## TECHNICAL NOTE

**Project Title:** Branch Hill, Hampstead

**Report Reference:** JNY9823-05b

### TRANSPORT NOTE

### PROPOSED BASEMENT PLAN

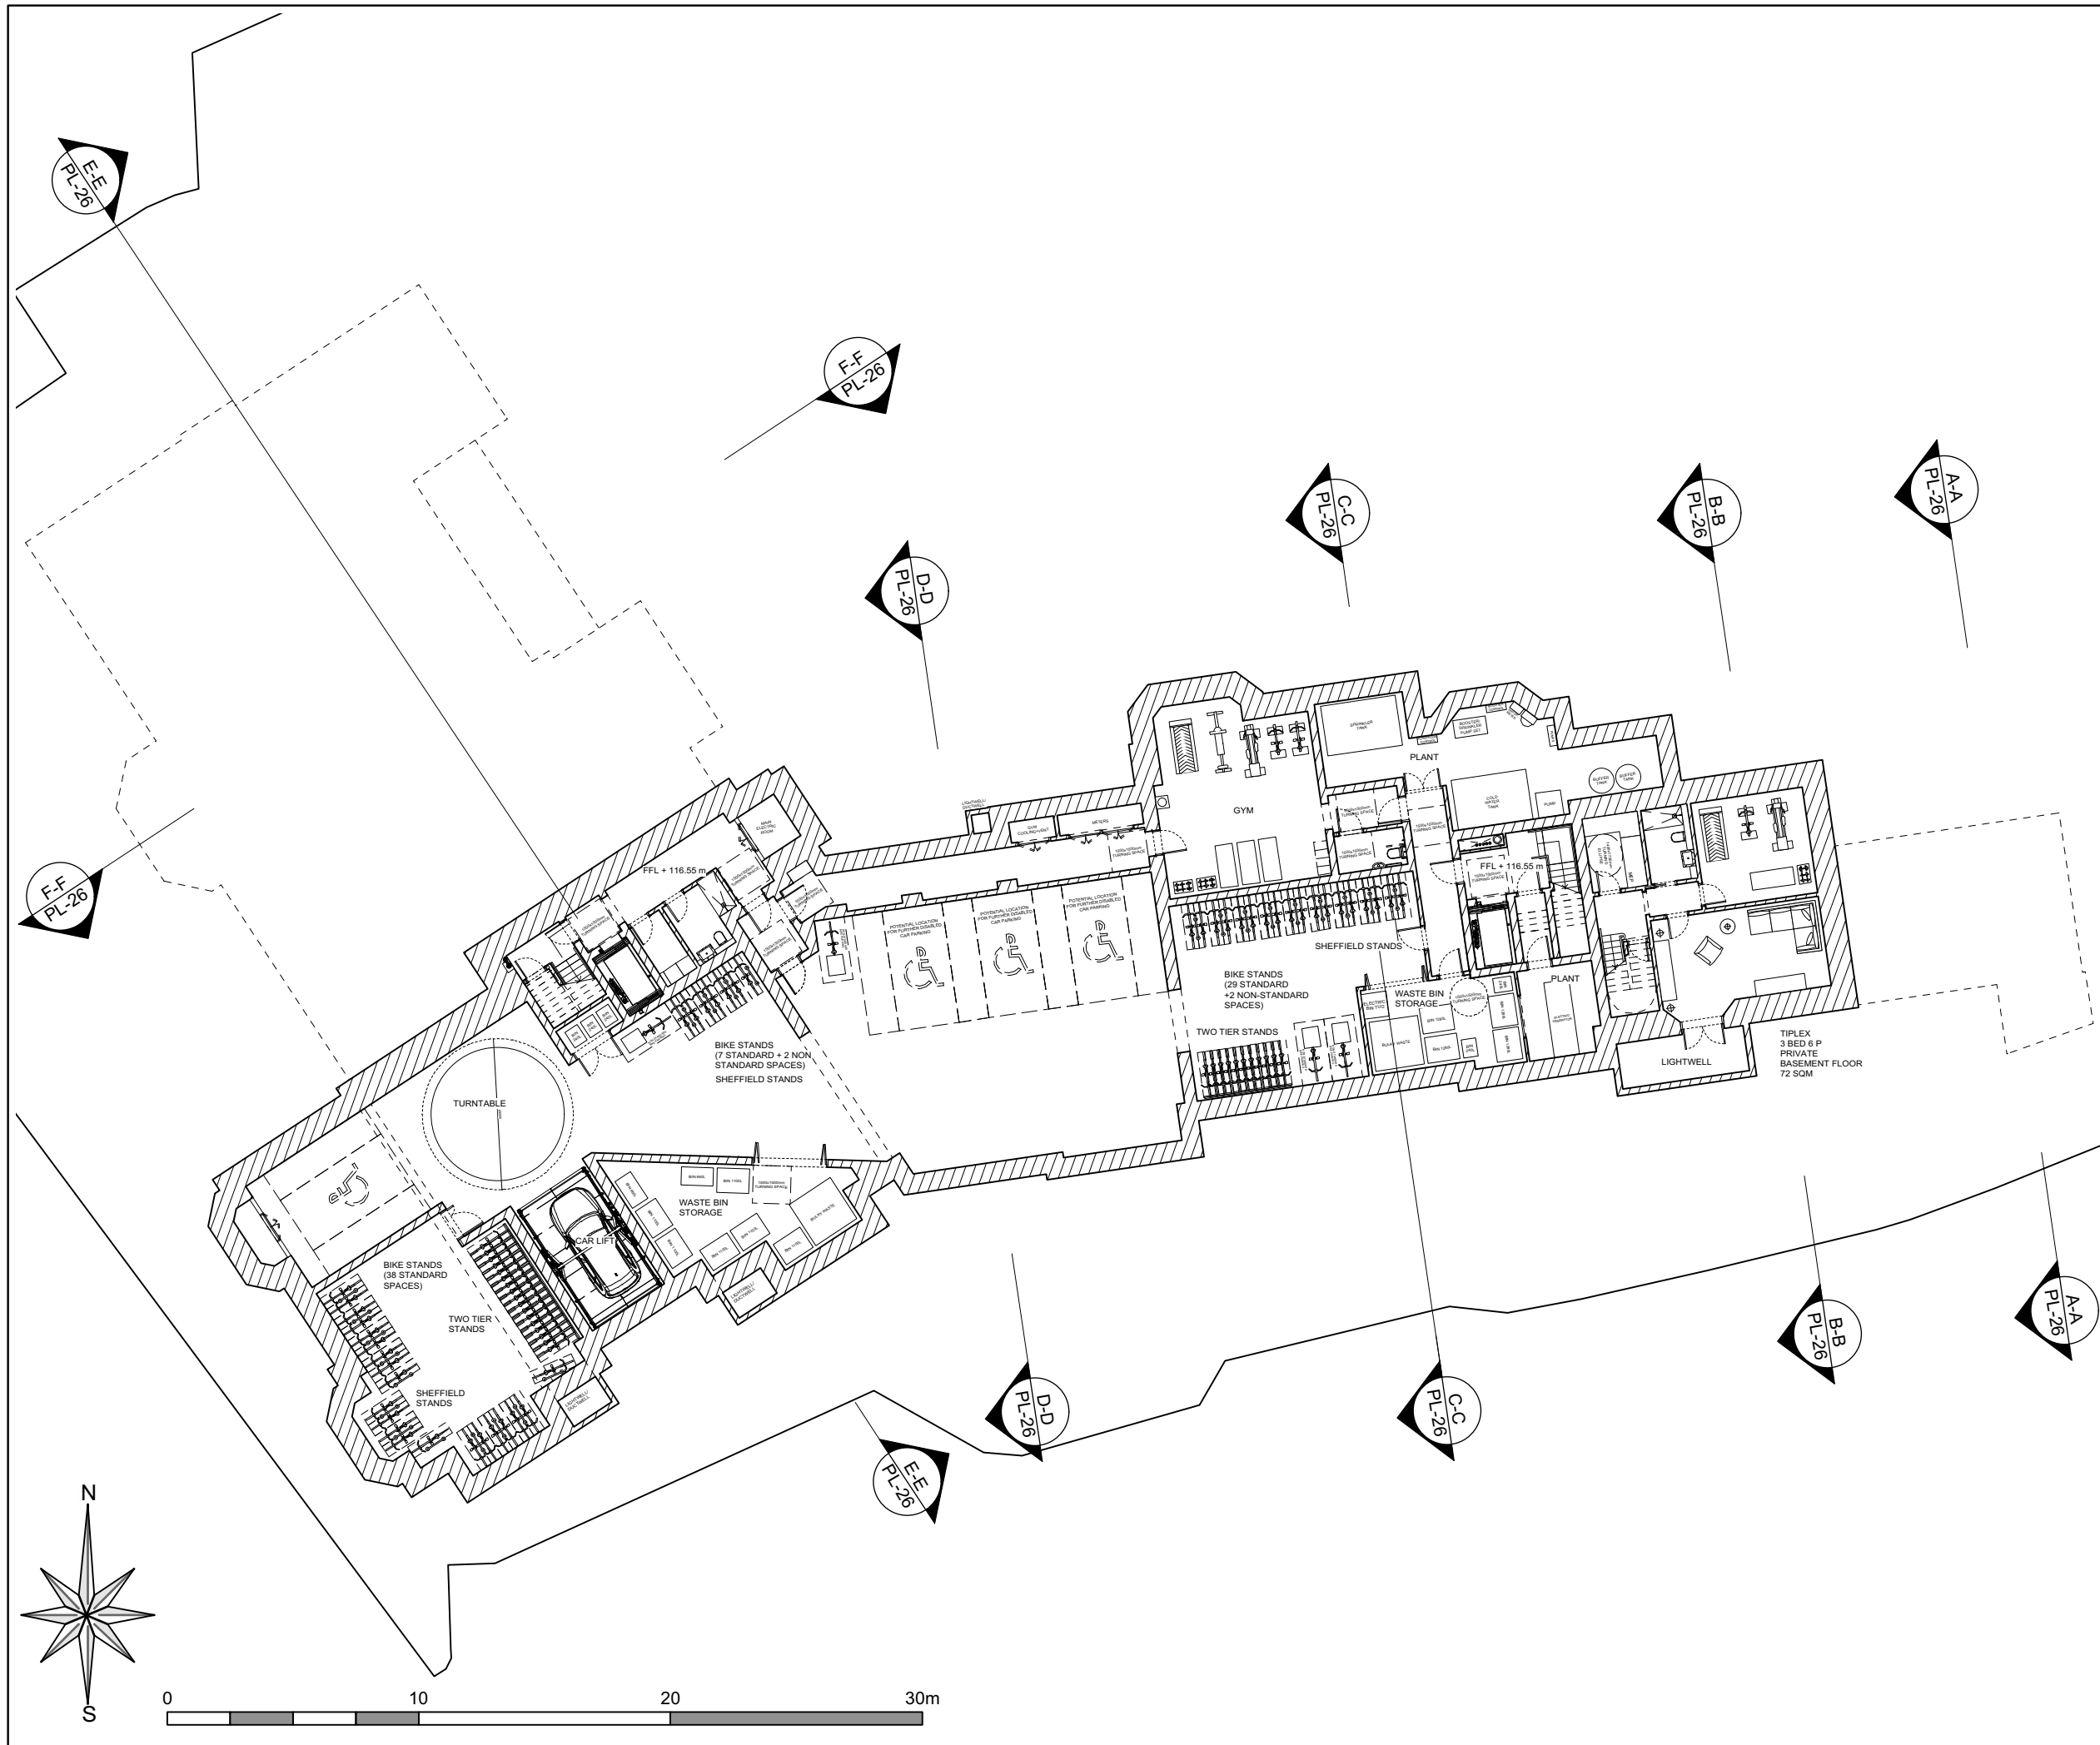
- 1.1 This Transport Note has been prepared in response to Camden Council's consultation responses dated 27 February and 12 March 2020, requiring that:
1. a single disabled car parking spaces be provided at grade with a plan showing where future provision could be provided within the site if the need arises; and
  2. cycle parking be provided that complies with the design requirements of CPG Transport.

- 1.2 It is proposed that all disabled parking provision is located within the basement, in line with policy requirements, as shown within the basement layout plan in **Appendix 1**.

- 1.8 The drawing provided in **Appendix 1** illustrates where up to three additional disabled car parking spaces could be provided, should the need arise. These would only be marked out if the need arises for the spaces and they would be marked out on a space by space basis. Thus, if demand for the maximum number of spaces (four) does not ever arise then the additional provision will not be marked out.

- 1.9 The drawing provided at **Appendix 1** illustrates the revised cycle parking provision. This is to be provided at basement level and incorporates a total of 74 standard cycle parking spaces provided in a combination of Sheffield stands (46 spaces) and two-tier cycle parking (28 spaces) plus four (5% of the total provision) non-standard cycle parking spaces to cater for larger cycles.
- 1.10 The proposed provision complies with the requirements of CPG Transport, through providing the majority of the standard cycle parking (62%) in the form of Sheffield stands with the residual provided in the form of two-tier cycle parking (38%), thereby catering for people of all abilities.
